## **SIL SG102-01 SG102 AHRS Service Information Letter**

Regarding: SG102 Installation Manual Correction

In SG102 Installation Manual, 82011-IM Rev A, SG102 P2 pins A and C are shown reversed

SIZE	CAGE CODE	DWG NO.	REV
B	3T1Z4	82011-10	B
SCALE	NONE		SHEET 4 of 5

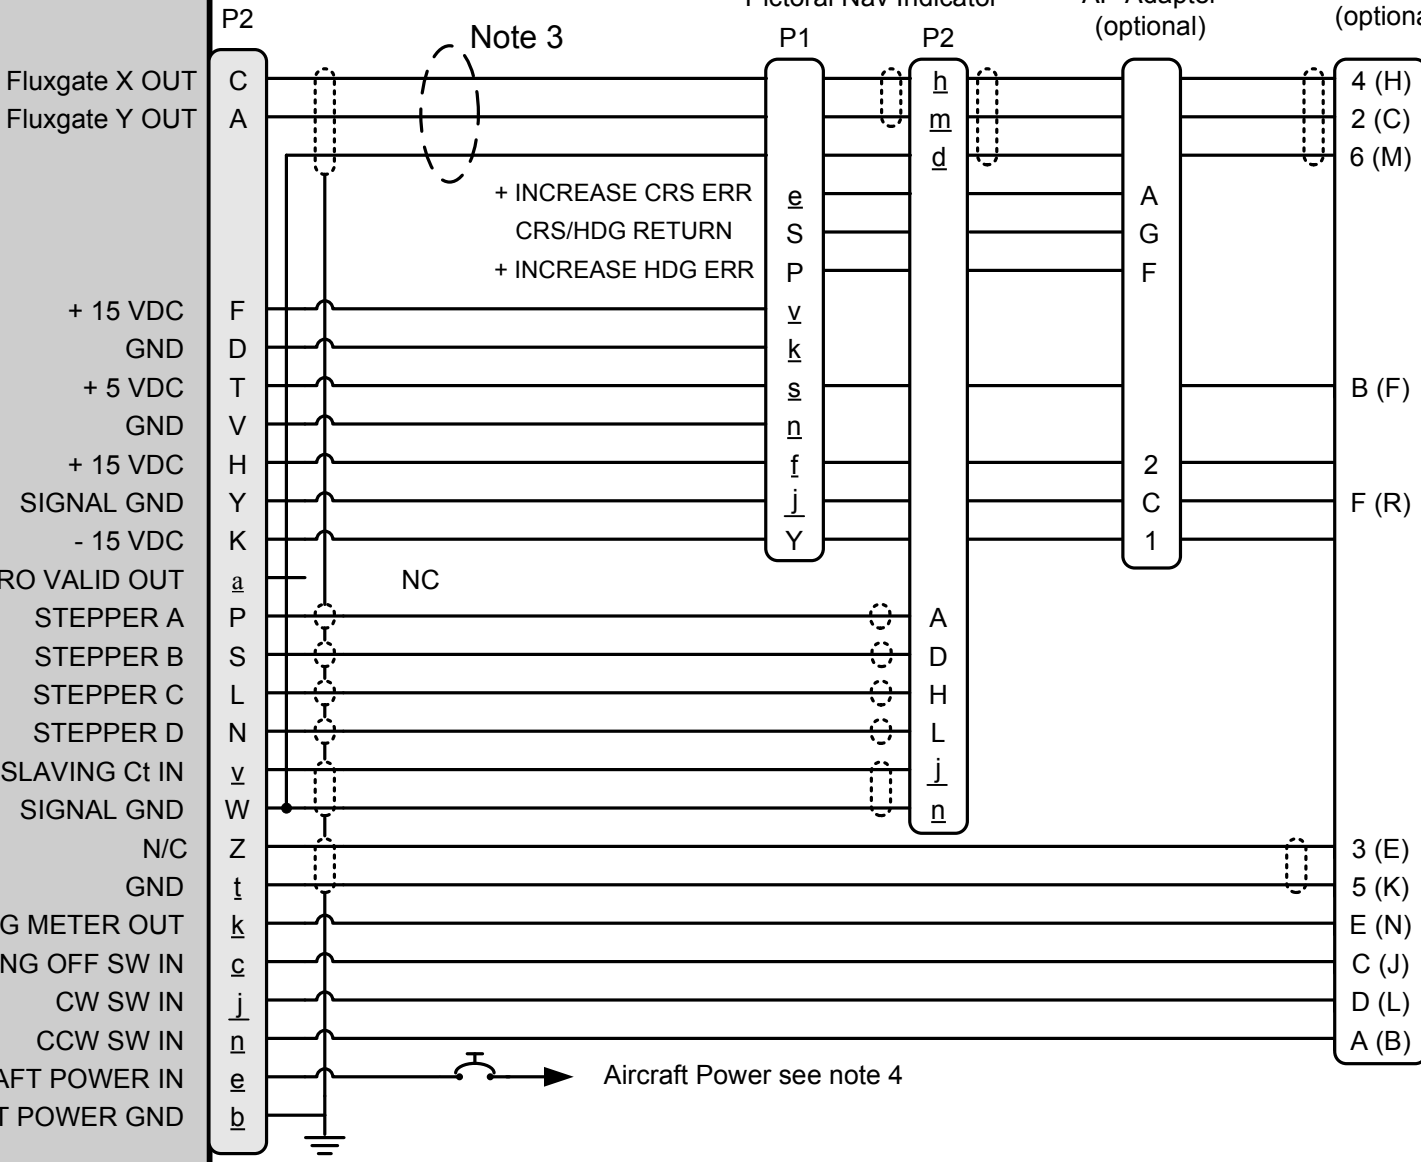
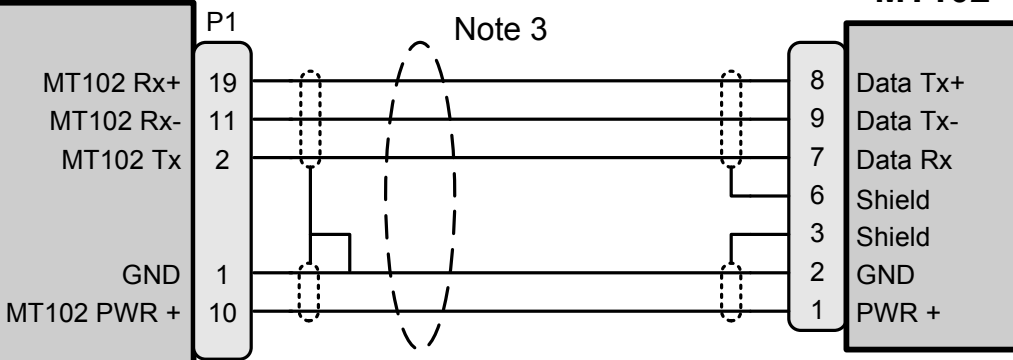
On drawing 82011-10, page 4 Rev A and page 5 Rev A, SG102 P2 pins A and C are shown reversed. If these connections are wired as originally shown, the KI525 will not slave to the correct heading. If these connections are used, ensure they are made according to the corrected documentation.

ZONE	LTR	DESCRIPTION	DATE	APPROVED
All	A	Initial Release	01-DEC-2007	
	B	AR #972 - SG102 P2-A & P2-C swapped	06-MAR-2008

Discard the original pages, and insert the two attached pages (82011-10, pages 4 & 5, both Rev B) into the installation manual and update the list of effective pages.

SIZE: <b>B</b>	CAGE CODE: 3T1Z4	DWG NO.: <b>82011-10</b>	REV: <b>B</b>
SCALE: NONE		SHEET 5 of 5

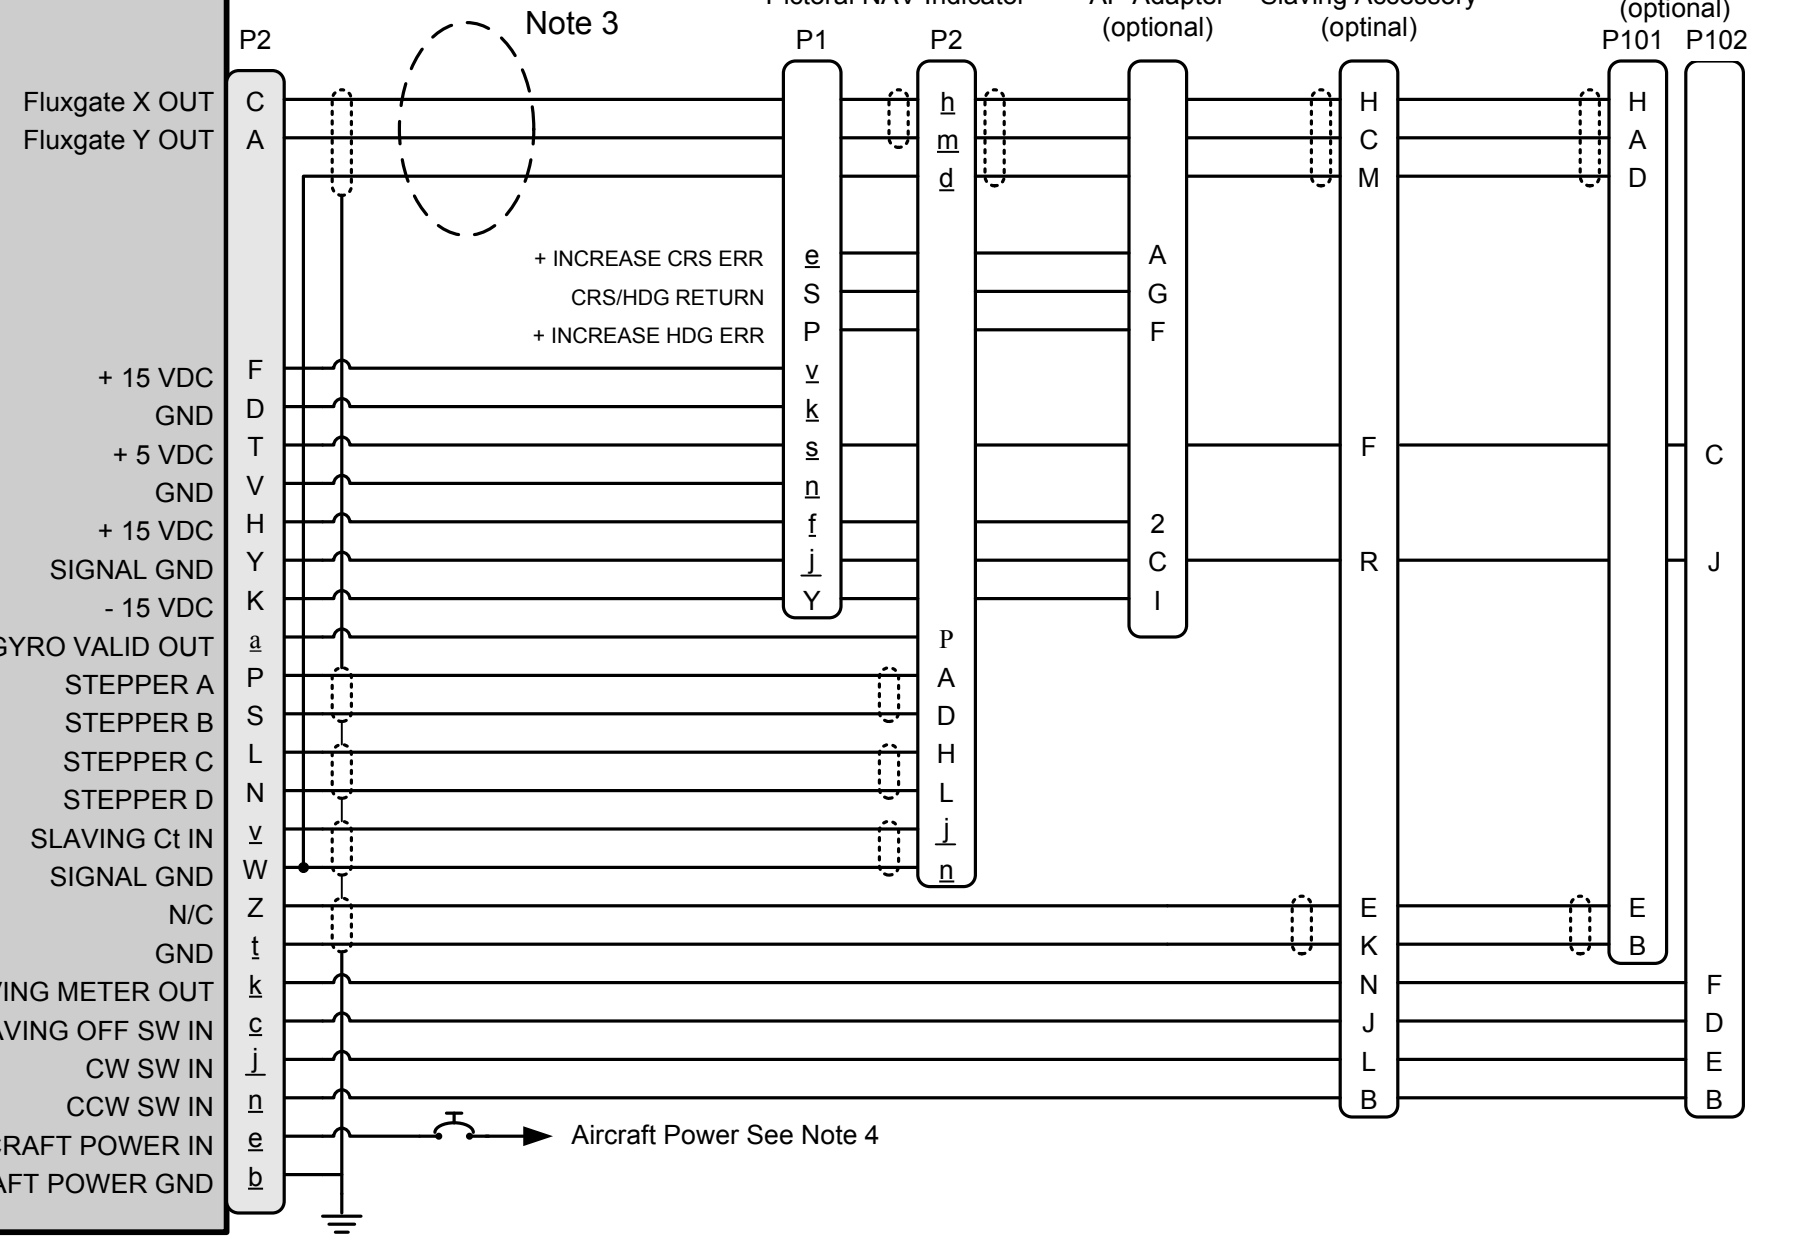
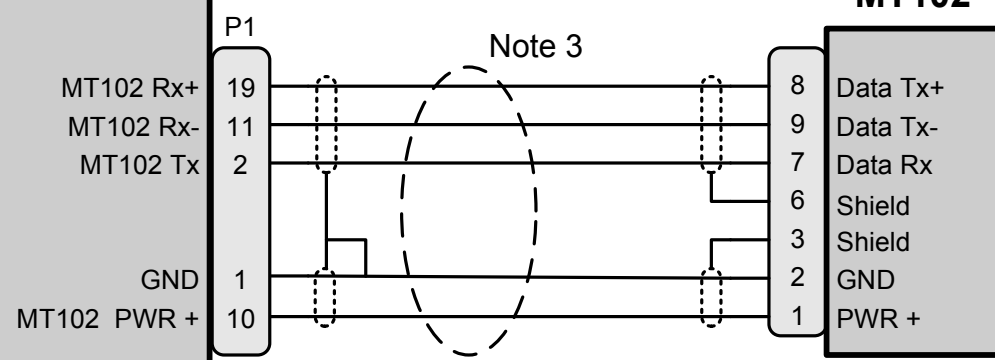
REVISIONS				
ZONE	LTR	DESCRIPTION	DATE	APPROVED
All	A	Initial Release	01-DEC-2007	
	B	AR #972 - SG102 P2-A & P2-C swapped	06-MAR-2008
